STATE OF CONNECTICUT
CONNECTICUT SITING COUNCIL

IN RE: :
 :
APPLICATION OF CELLCO PARTNERSHIP : DOCKET NO. 475
D/B/A VERIZON WIRELESS FOR A :
CERTIFICATE OF ENVIRONMENTAL :
COMPATIBILITY AND PUBLIC NEED FOR :
THE CONSTRUCTION, MAINTENANCE AND :
OPERATION OF A WIRELESS :
TELECOMMUNICATIONS FACILITY OFF :
FOLLY LANE, COVENTRY, CONNECTICUT : SEPTEMBER 13, 2017

**RESPONSES OF CELLCO PARTNERSHIP D/B/A VERIZON WIRELESS
TO CONNECTICUT SITING COUNCIL PRE-HEARING INTERROGATORIES**

Farmland Soils
Proposed Wireless Telecommunications Facility
 Coventry Northwest CT
 Folly Lane
 Coventry, Connecticut
 verizon

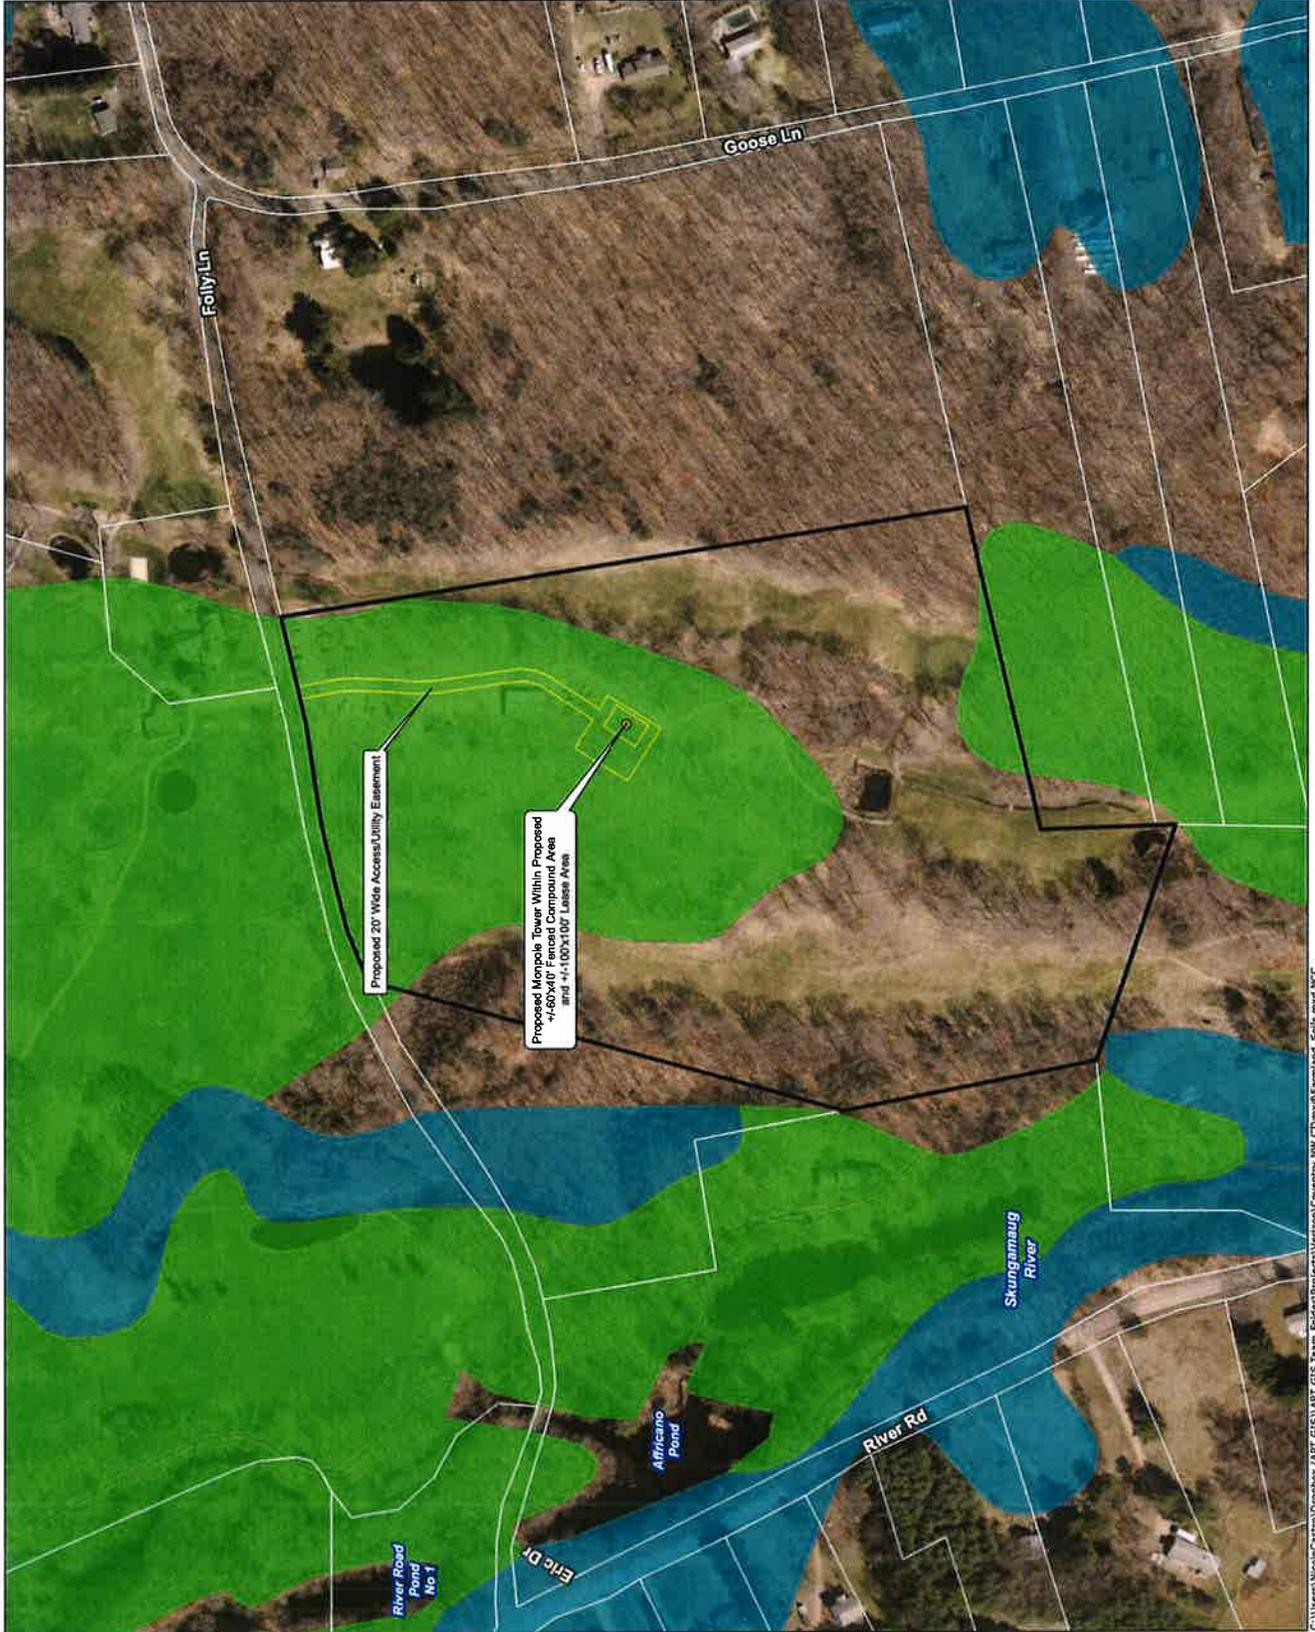
Does the proposed site contain any Connecticut Prime Farmland and/or Important Agricultural Soils? If so, what is the acreage of prime and important soils that would be impacted by the proposed facility? Is any portion of the site currently in productive agricultural use?

Farmland soils suitable for agricultural use includes land that is defined as prime or farmland of Statewide or local importance, based on soil type. It identifies the location and extent of the most suitable land for producing food, feed, fiber, forage, and oilseed crops and is available for these uses. According to the National Cooperative Soil Survey (U.S. Department of Agriculture, Natural Resources Conservation Service), north central portions of the Property contain “Statewide Important” Farmland soils, including areas where the Canterbury South Facility compound and gravel access drive upgrades are proposed. (See Farmland Soils Map included in Attachment 1). This area, however, is currently occupied by an existing driveway, maintenance facility and portions of the existing golf course.
